Incorrect Starter Mounting Bolts

BULLETIN

Models Affected: 2009-2011 Model Year Vision with GM 8.1 L Propane Engines

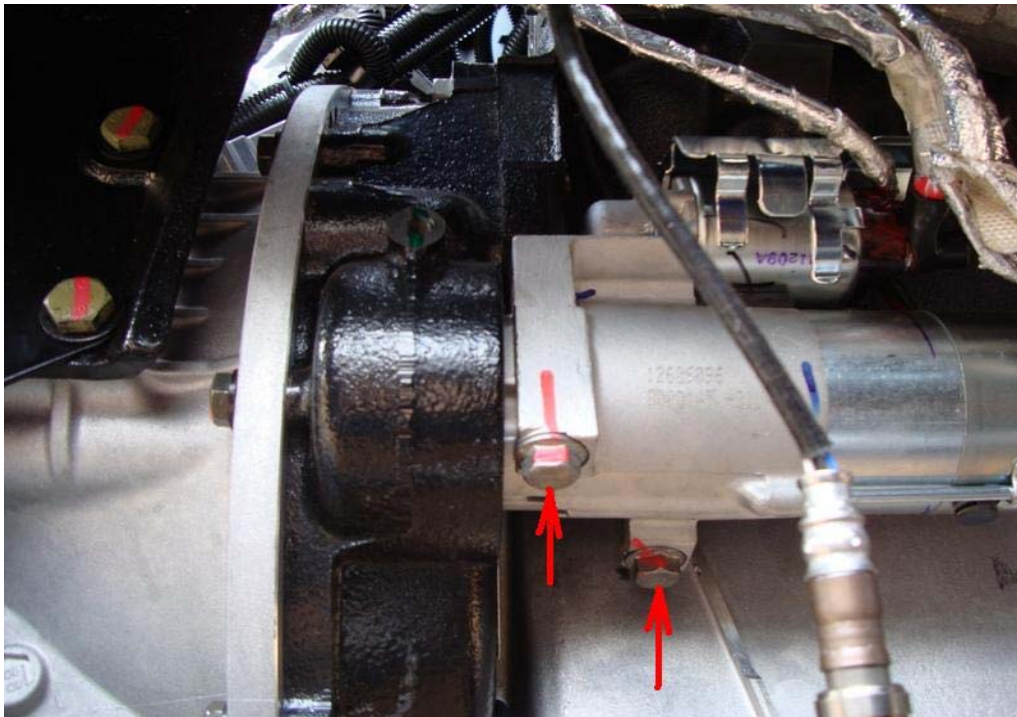
The flange on the starter mounting bolts is too large and prevents the bolt from seating properly. If the bolt does not seat properly it may become loose and cause starting problems.

Replace original starter mounting bolts with new mounting bolts with proper size flange.

3. Replace starter mounting bolts one at a time (so you don't have to remove the starter) with the new bolts (10003378). **Do NOT use any washers.** Torque: 37 FT-LB
4. Remove wheel chocks and place bus back in normal service.
